## REVISED RESPONSE TO REQUEST FOR ADDITIONAL INFORMATION

### APR1400 Design Certification

RAI No.: 311-8278

SRP Section: 03.12 - ASME Code Class 1, 2, and 3 Piping Systems and Piping Components and Their Associated Supports

12  
Figure 6-11 High-Frequency Screening Process

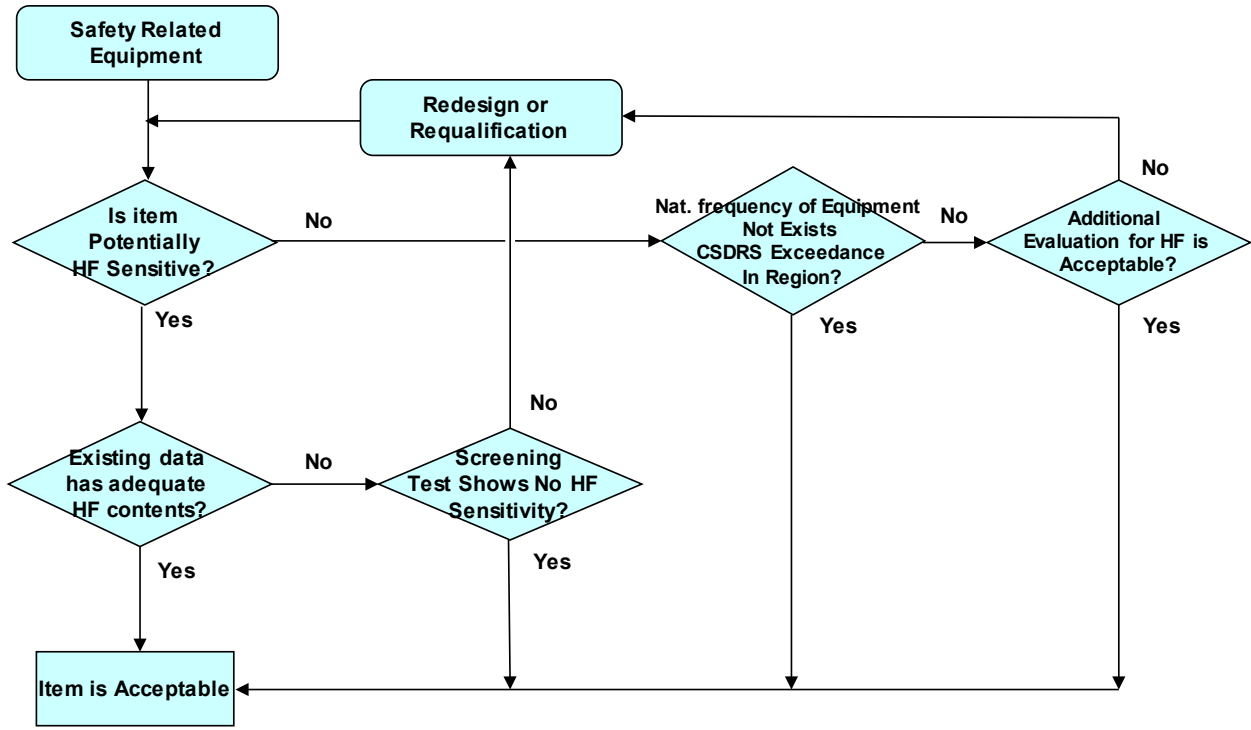
Add "C" in the previous page

Insert "D" in the next page
